Santa Catalina Towers Restroom & Deck Renovation
Project No. FM090053S/987711

Addendum No. 2

ADDENDUM NUMBER 2
to the
CONSTRUCTION DOCUMENTS

DOOR TYPES
SHEET A-5.1

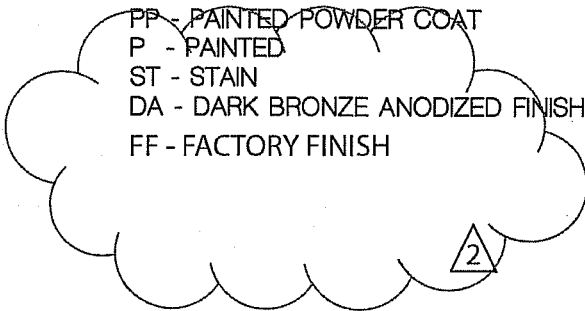
3. Sheet A-5.1 “Schedule and Details”:
Replace Door Types Notes in its entirety with attached Door Types Notes.
4. Sheet A-5.1 “Schedule and Details”:
Replace Typ. Door Jamb/Head Sim. in its entirety with attached Typ. Door Jamb/Head Sim..

DECKING DETAIL - 8
SHEET A-7.1

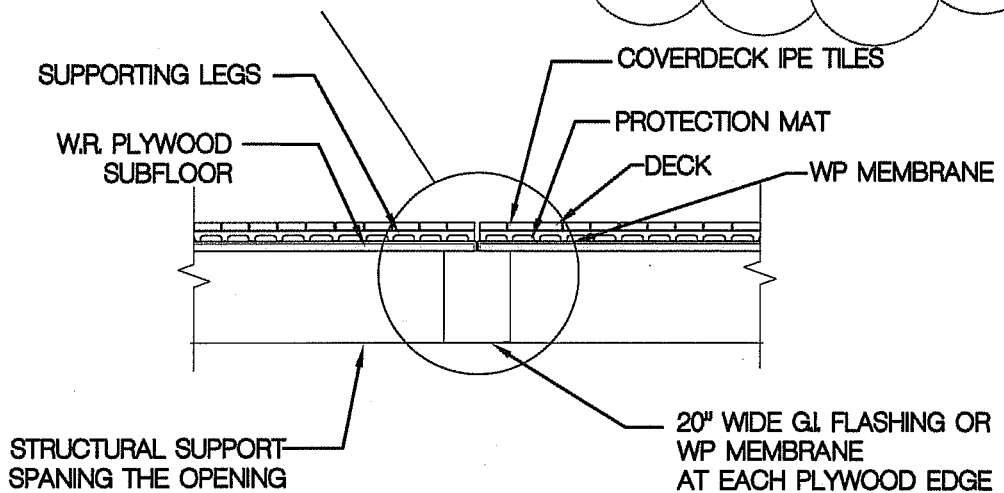
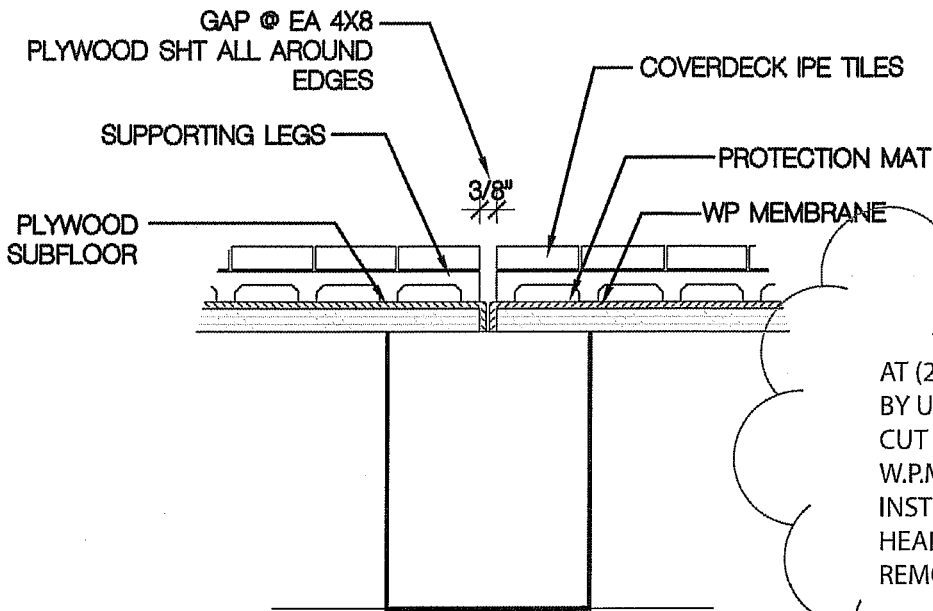
5. Sheet A-7.1 “Details”:
Replace Decking Detail Note 8 in its entirety with attached Decking Detail Notes.
6. Sheet A-7.1 “Details”:
Replace New Wall Detail Note 1 in its entirety with attached New Wall Detail Notes.

DECK ATTACHMENT @ (E) WALL
SHEET S3.1

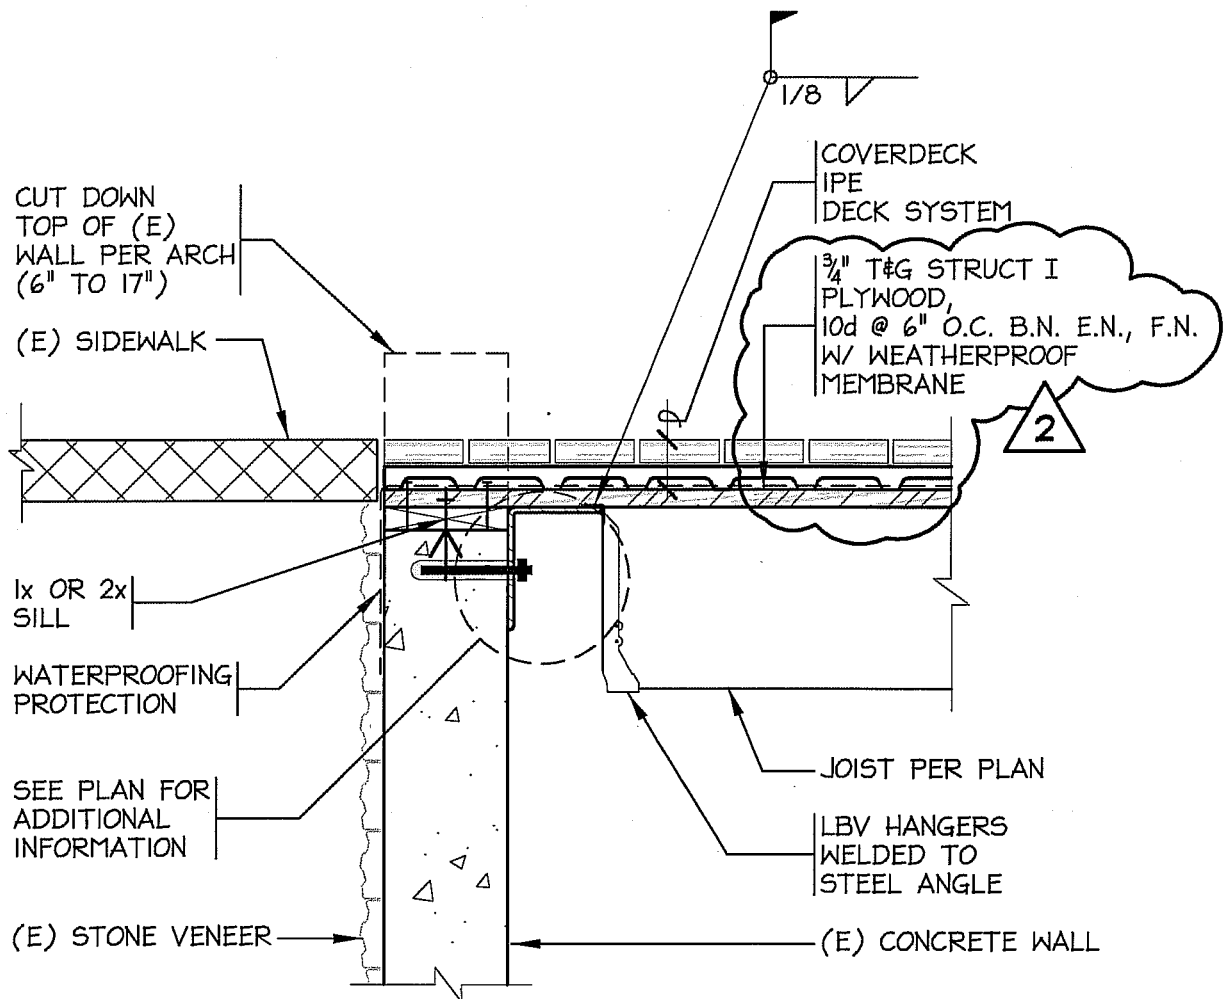
Replace Deck Attachment @ (E) Wall Note 3 in its entirety with attached Deck Attachment @ (E) Wall Note 3.

SHEET S3.1

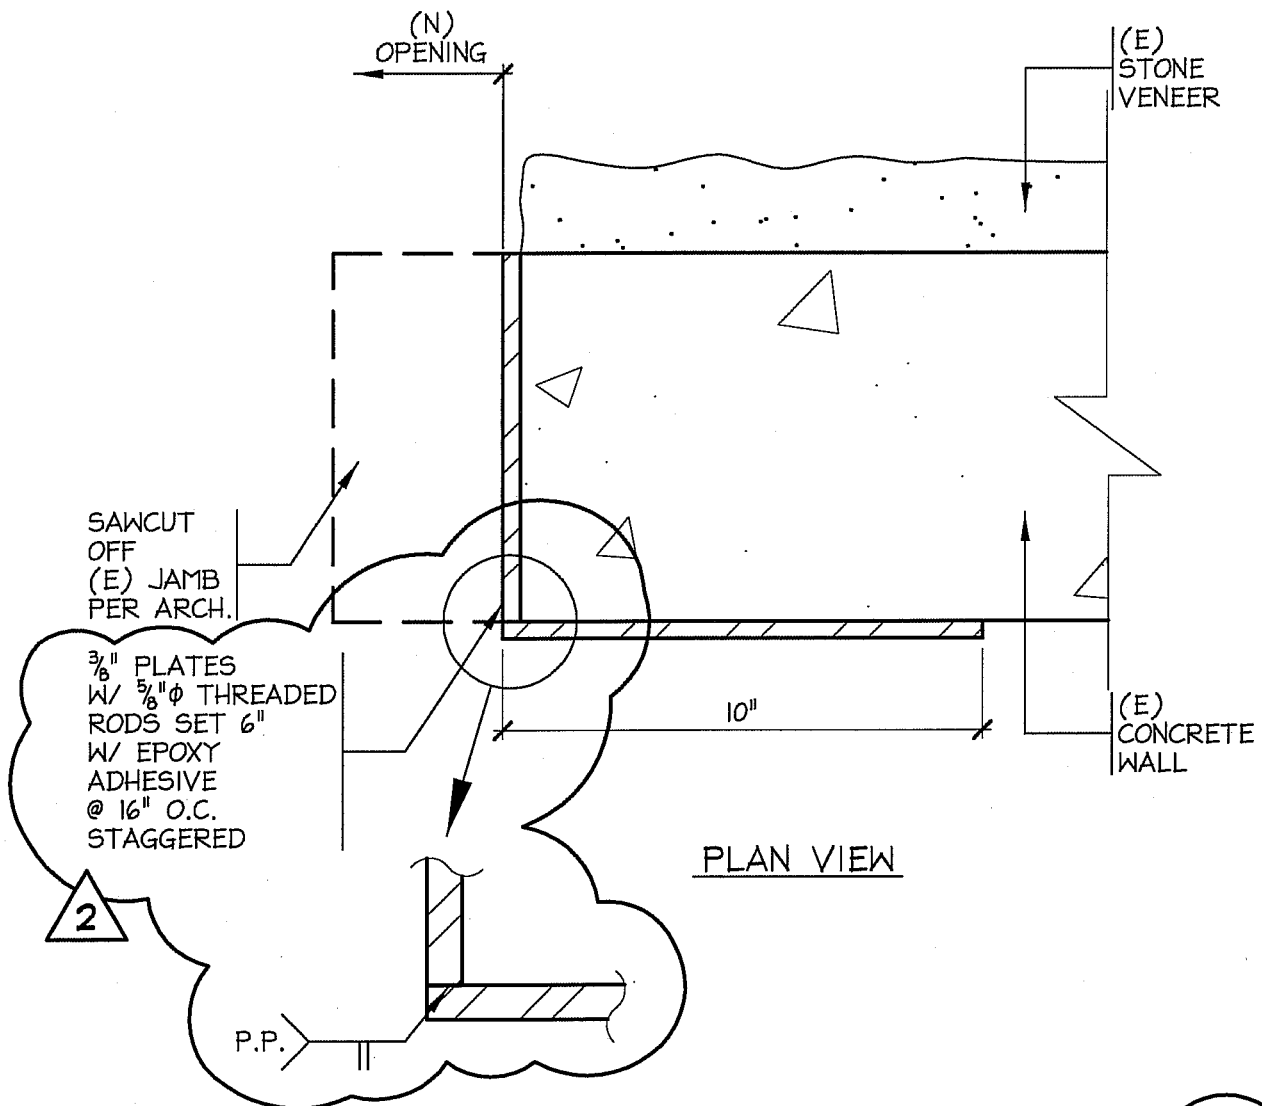
Replace (N) Jamb @ (E) Concrete Wall Note 6 in its entirety with attached (N) Jamb @ (E) Concrete Wall Note 6

E-1

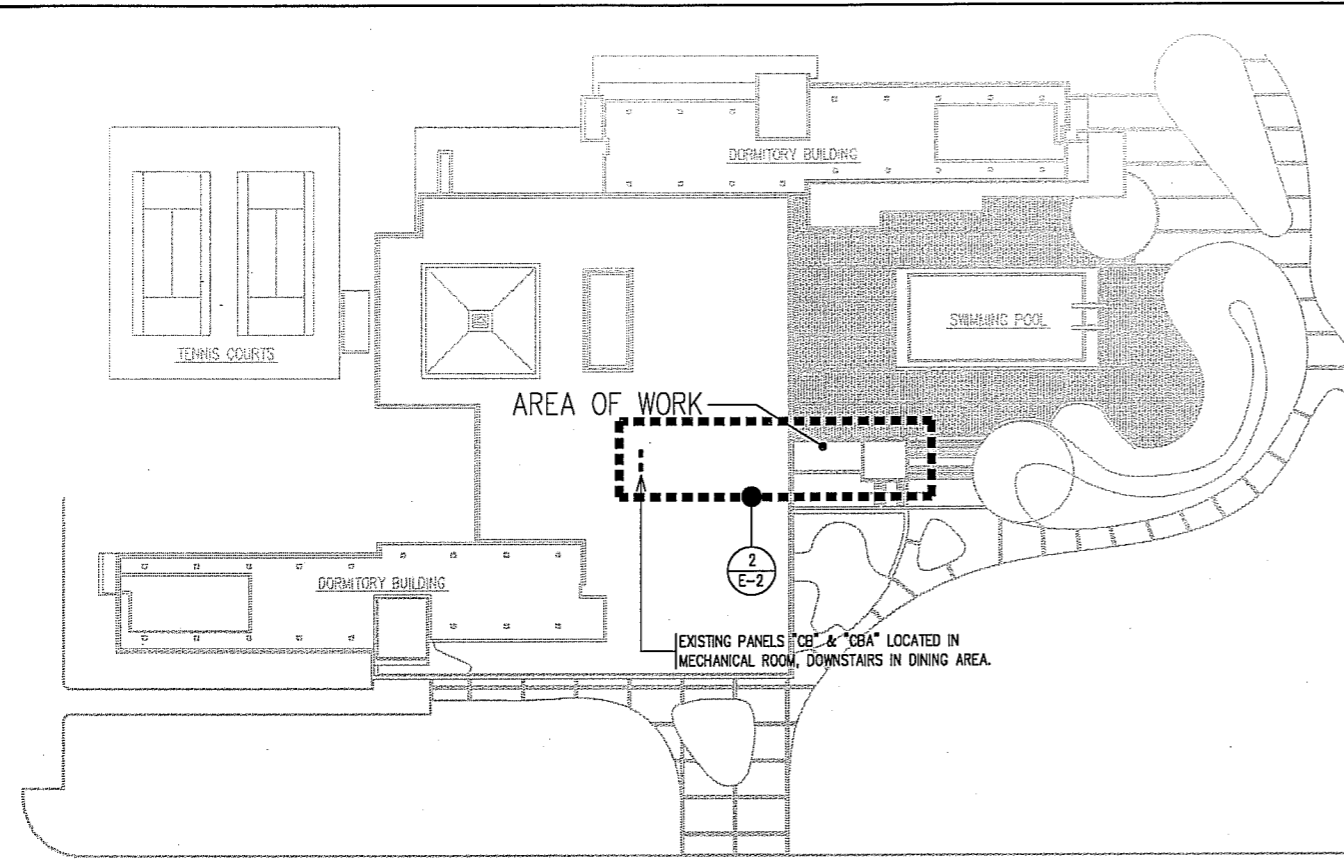
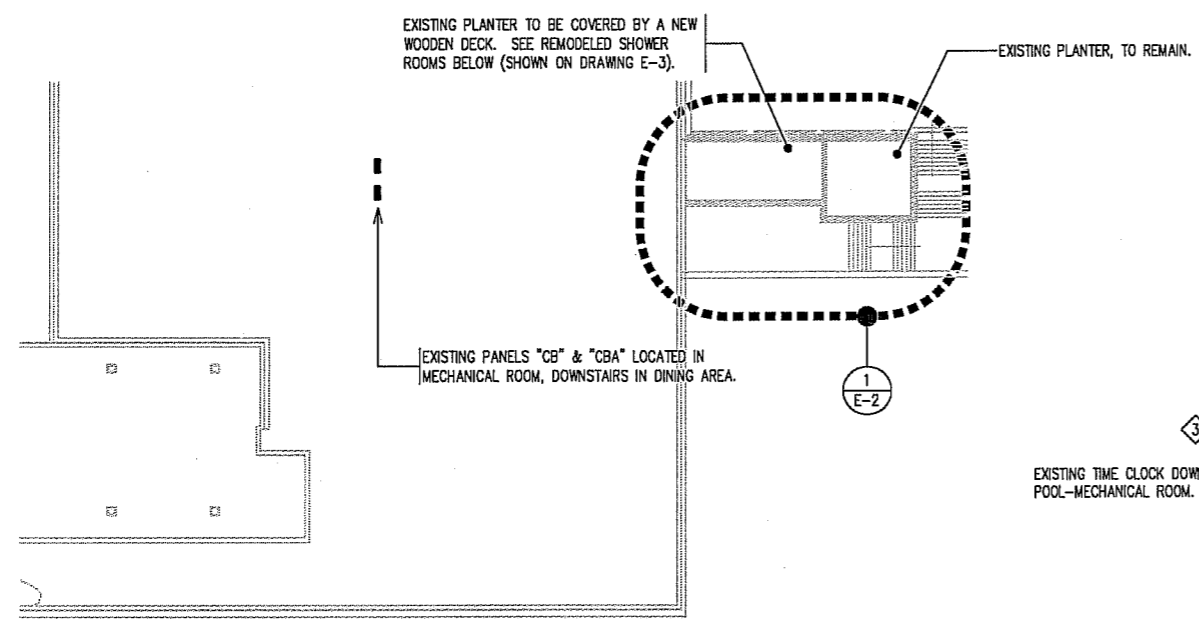
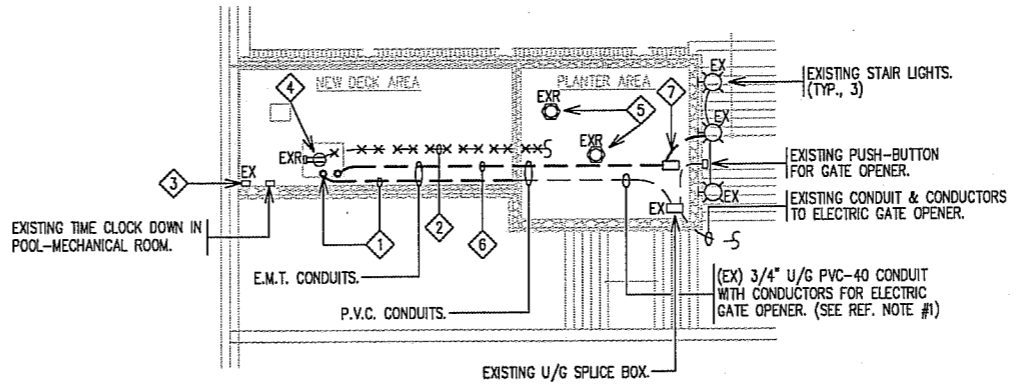
8. Sheet E-1 “Lighting Fixture Schedule Symbols”:
Replace in its entirety with attached E-1 Lighting Fixture Schedule Symbols.
9. Sheet E.2 “Site Electrical Plan Schedules”:
Replace Registered Professional Electrical Engineer Stamp with Signed Registered Professional Electrical Stamp.

**POOL SHOWERS
ELECT. PLANS,
DIAGRAMS**

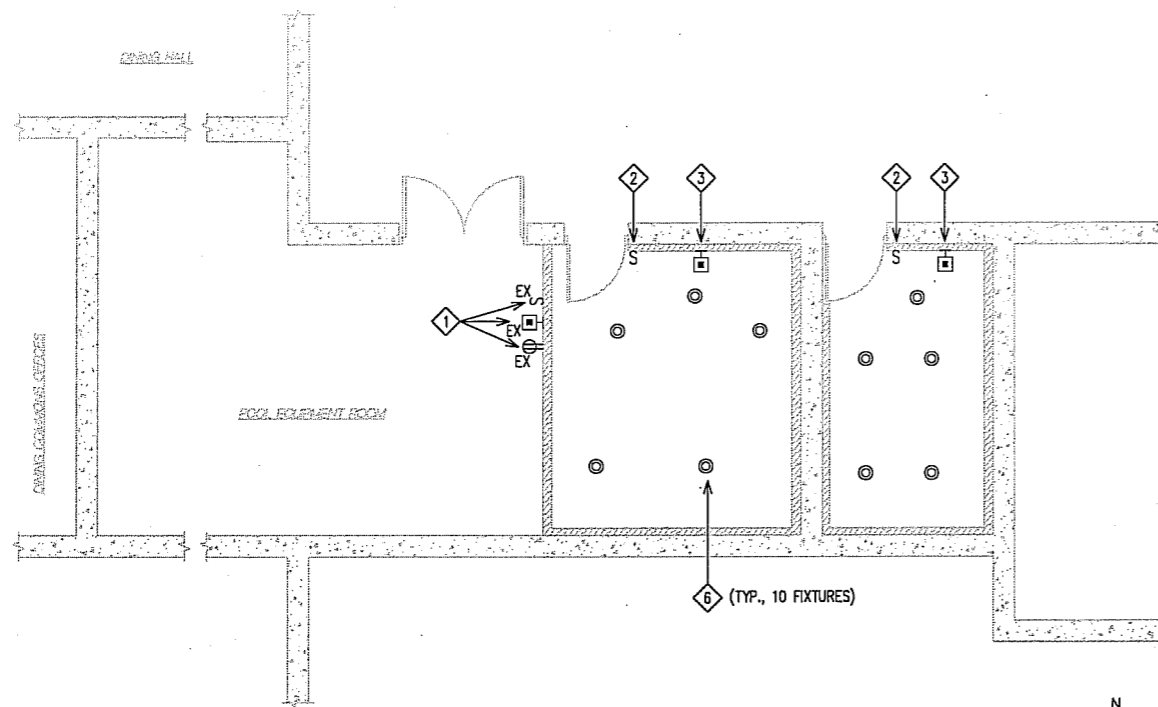
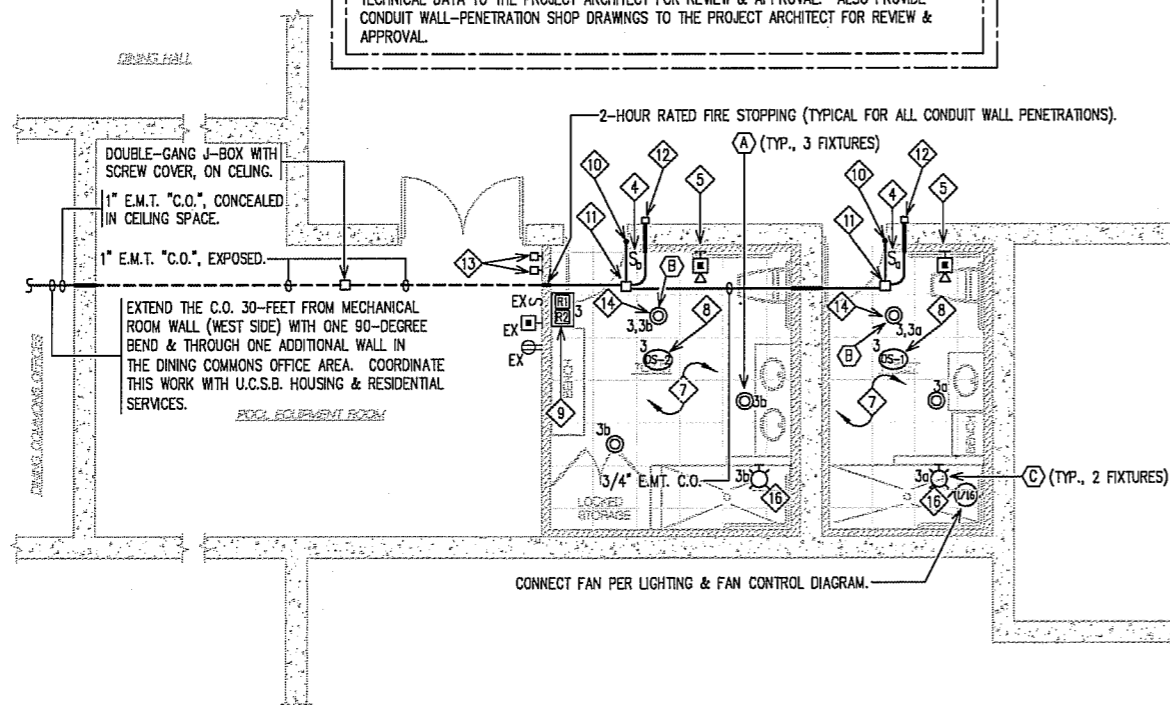
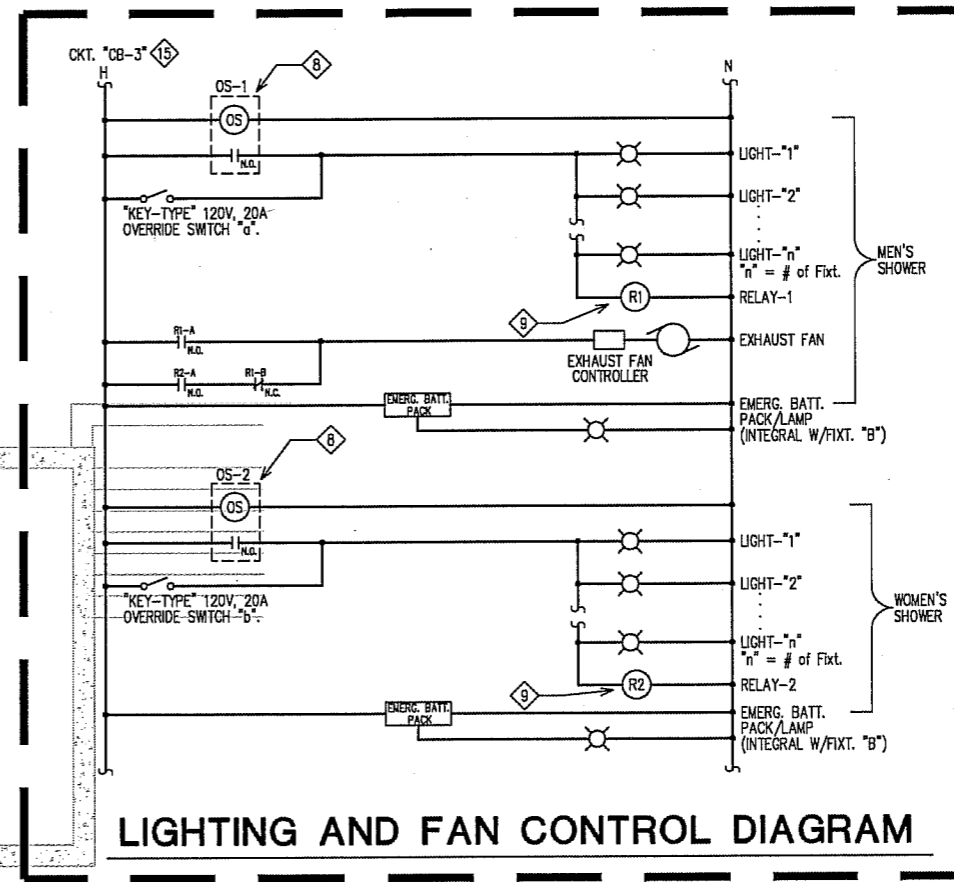
12. Sheet E-3 “Pool Showers, Electrical Plans, Diagrams”:
Replace in its entirety with attached E-3 Pool Showers, Electrical Plans, Diagrams
13. Sheet M.1 “Abbreviations, Symbols, Schedules, & Mechanical Demo Plan”:
Replace Registered Professional Mechanical Engineer Stamp with Signed Registered Professional Mechanical Stamp.

PLUMBING FLOOR & ROOF PLANS

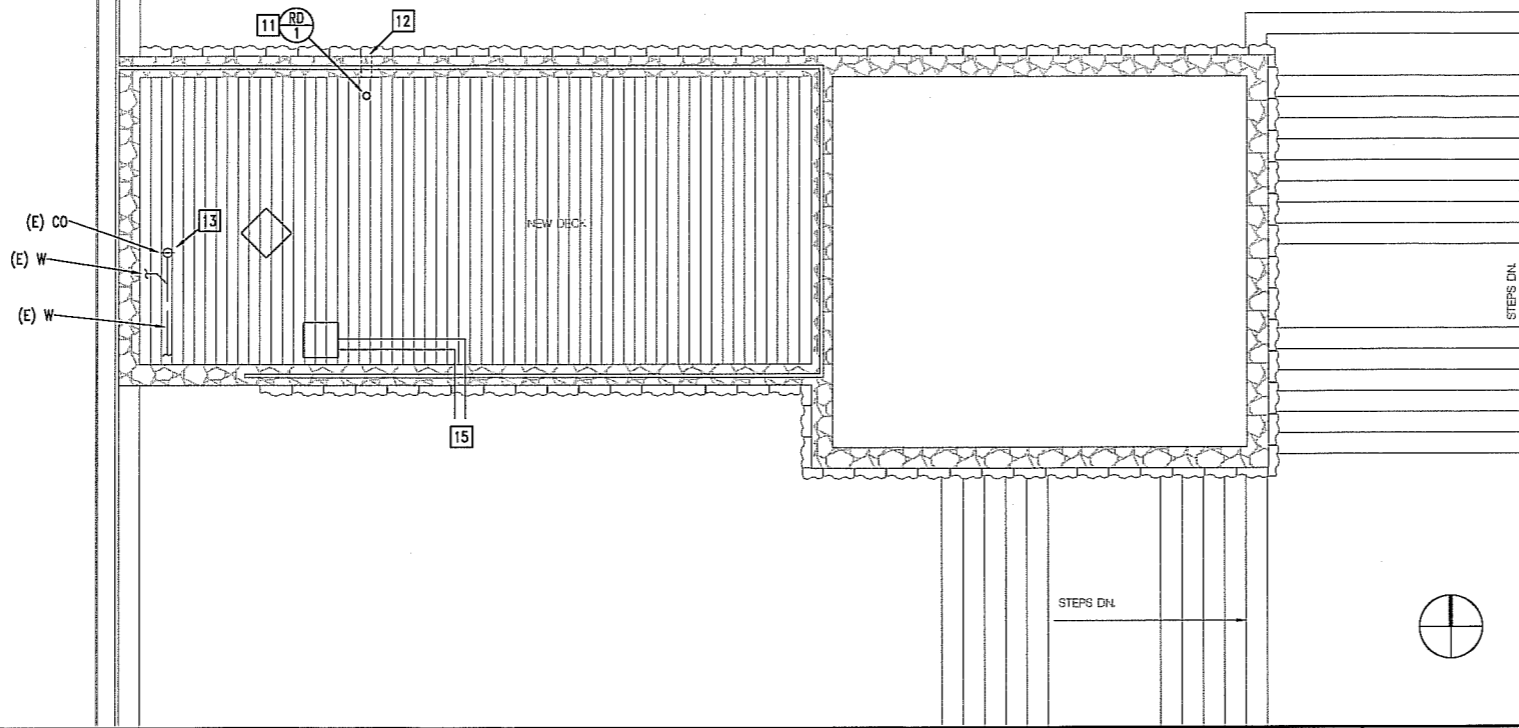
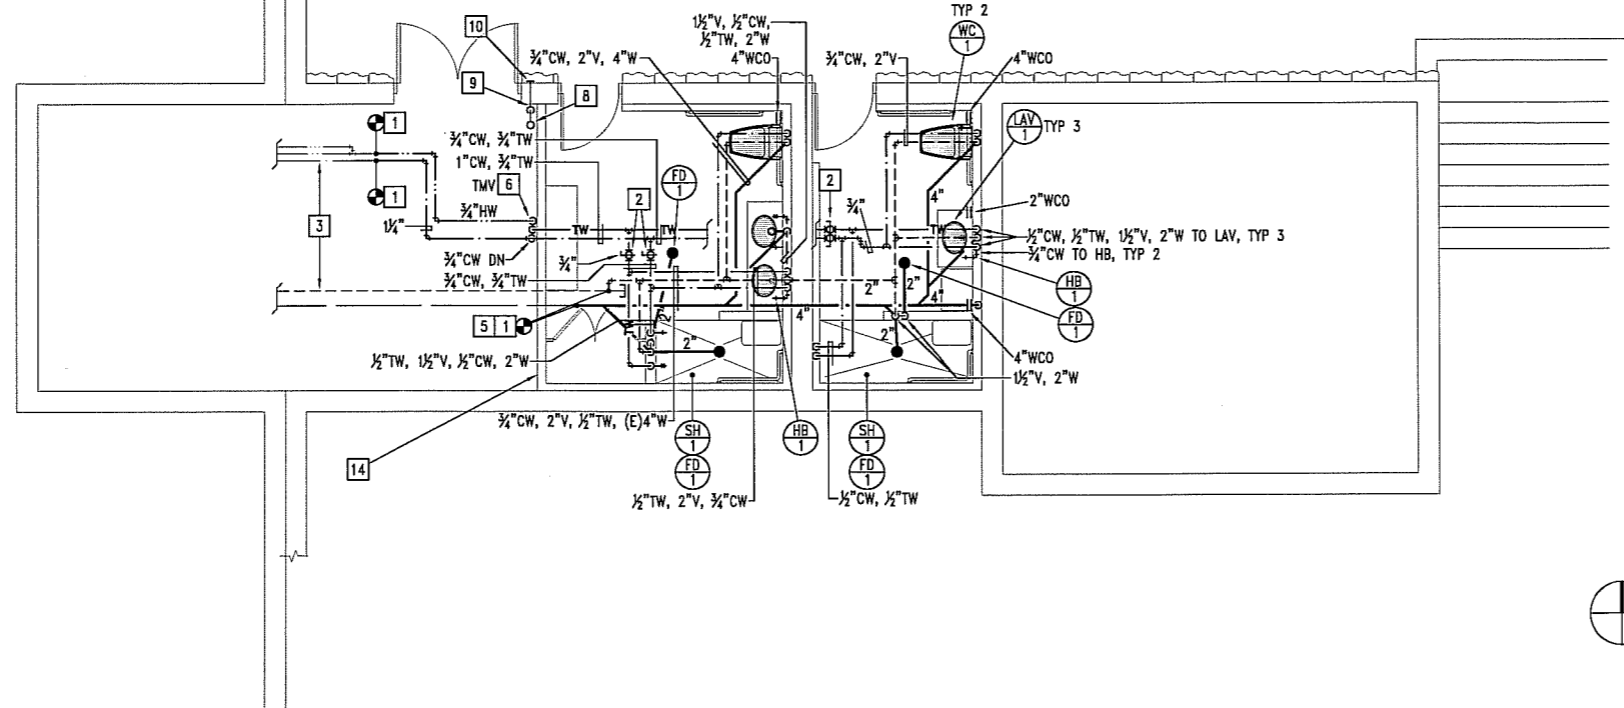
19. Sheet P.2 “Plumbing Floor & Roof Plans”:
Replace Registered Professional Engineer Stamp with Signed Registered Professional Stamp.
20. Sheet P-2 “Plumbing Floor & Roof Plans”:
Replace in its entirety with attached P-2 Pool Showers, Electrical Plans, Diagrams
